3 October 2012

RE: Macarthur Road, Spring Farm – Flood Impact Assessment – Additional Information in response to OEH Letter Dated 24 September 2012 and DoPI enquiries dated 26 September 2012 (transcribed via email from Matt Collins)

Figure 5 - 100 Year Flood Hazard (Velocity x Depth) Difference

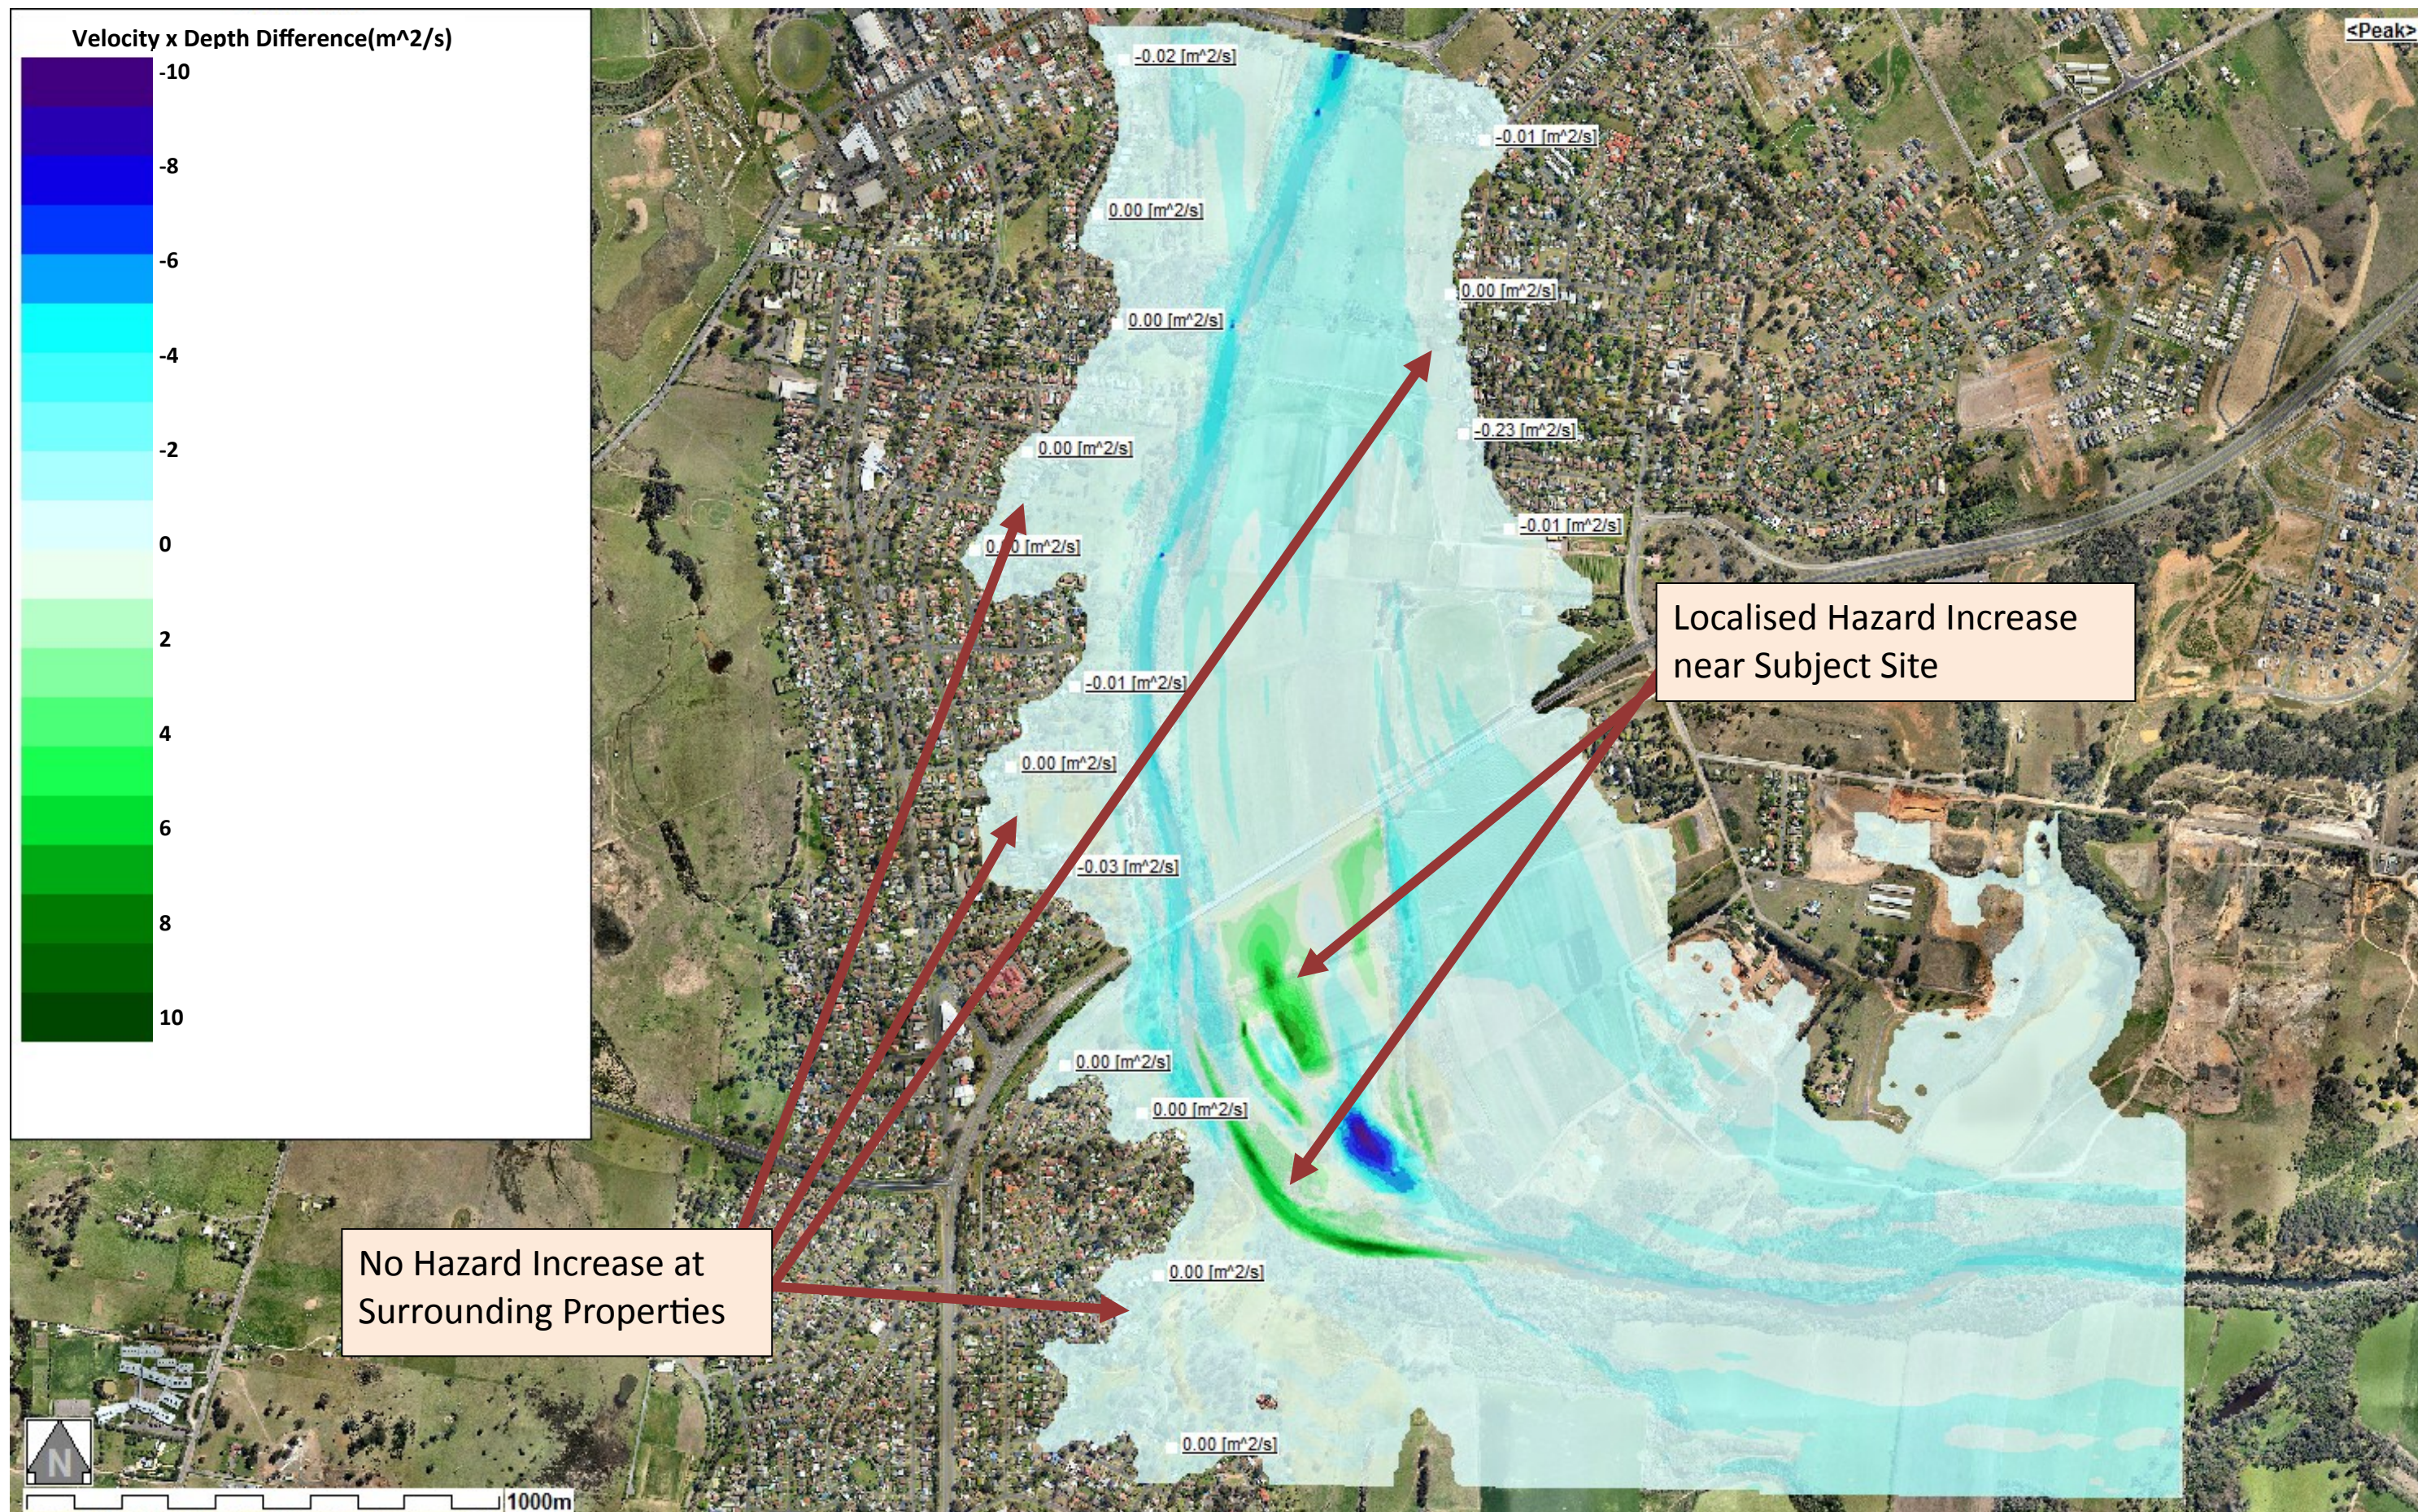
This report aims to address additional concerns raised by OEH in relation to the development, in particular the comment that reporting had not documented the effects of the development on flood levels and flood hazard at adjoining properties.

Figure 3 attached shows the existing Flood Hazard for the 100 year ARI, while **Figure 4** shows the Flood Hazard for the proposed case, for the 100 year ARI, and **Figure 5** shows the differences in the Flood Hazard for the 100 year ARI.

These results show there are no significant flood hazard effects predicted outside of the subject site for a range of recurrence intervals modelled, with the main effect being due to velocity changes post development being localised mostly within the subject site. For example, the model predicts velocity increases along the western boundary of the site (i.e. along the right bank of the Nepean River), as reported previously, and in some areas, the flood hazard changes accordingly, due to slight changes in velocity.

The modelling has demonstrated that adjoining and downstream properties are not impacted in terms of flood hazard, by the influence of floodwater as a result of the proposed sand extraction development.

Figure 6 - Proposed Terrain Levels

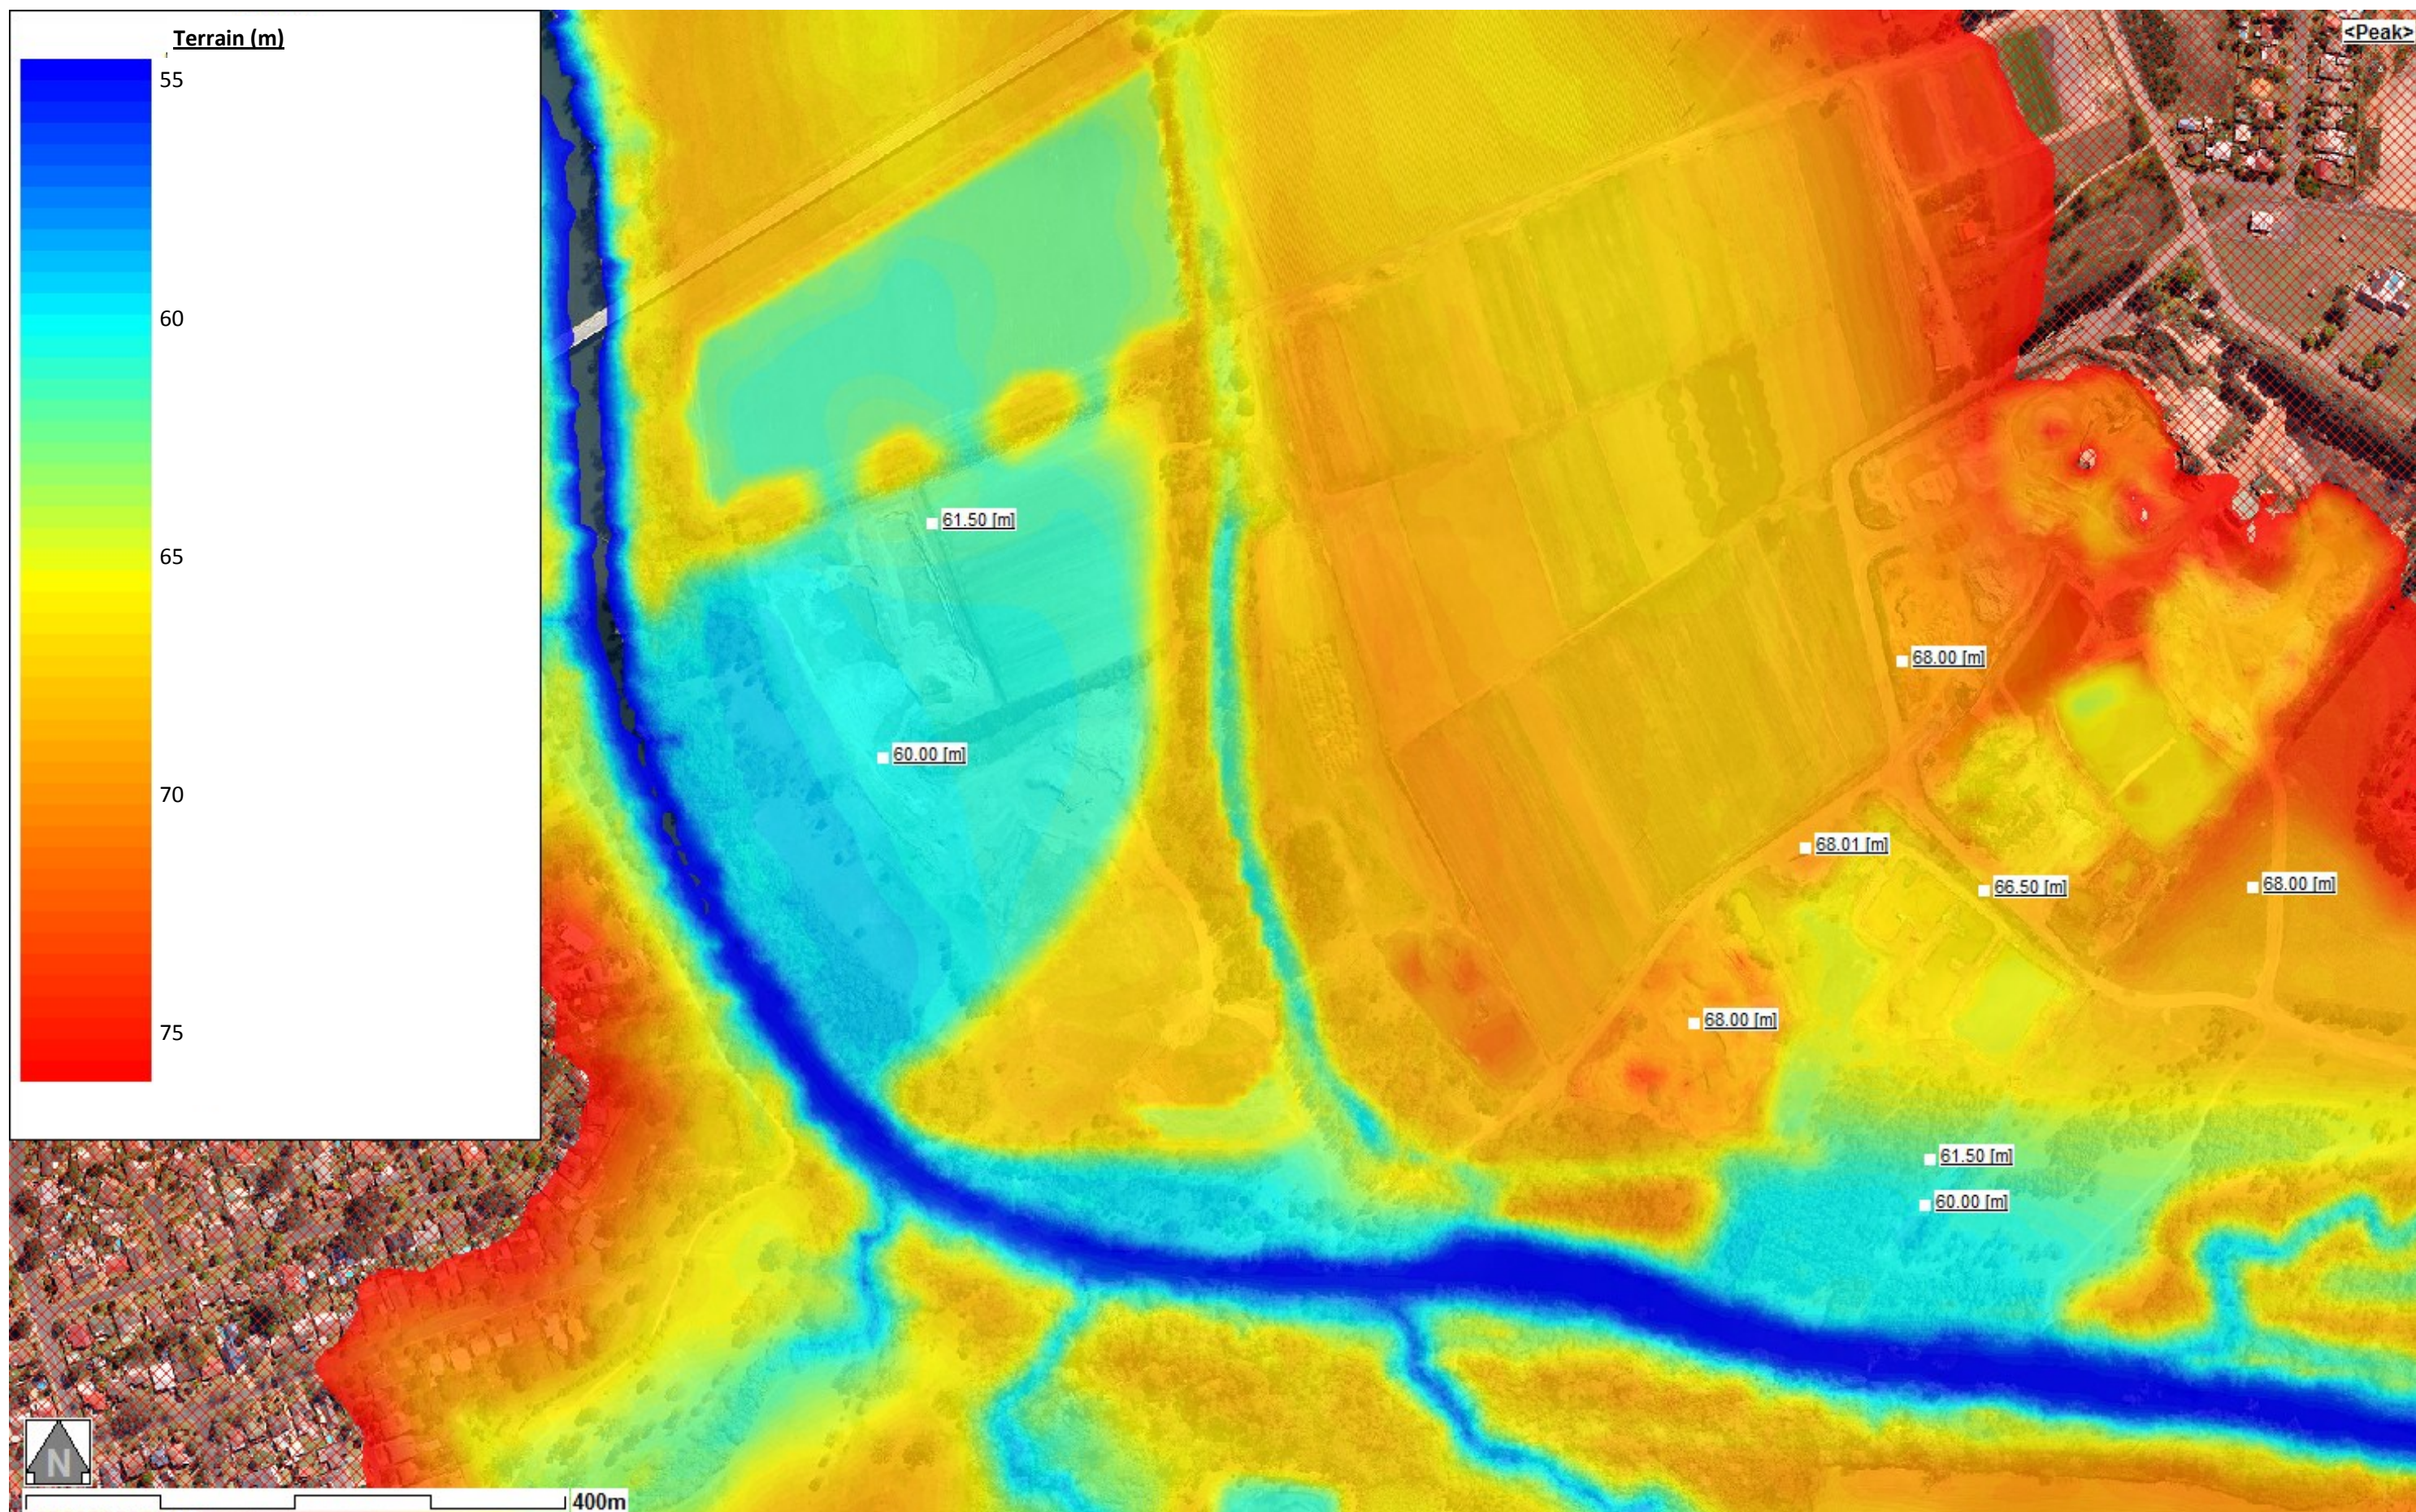
3.3 Predicted ARI at threshold of floodwaters entering the previously mined sites (i.e. Lot 1 and Lot 22)

Based on this relationship, the processing area of the site, which is located adjacent to Macarthur Road in Lot 1 has a natural ground level of approximately RL 68.0m, AHD, however, floodwater would first enter this area at, say RL 66.5m, AHD. This part of the site would begin to be inundated in events of an ARI of approximately 3 year ARI, but would not significantly be inundated until a 6 year ARI event (i.e. RL 68m, AHD). **Figure 6** shows approximate location of ground surface levels referred to in this report.
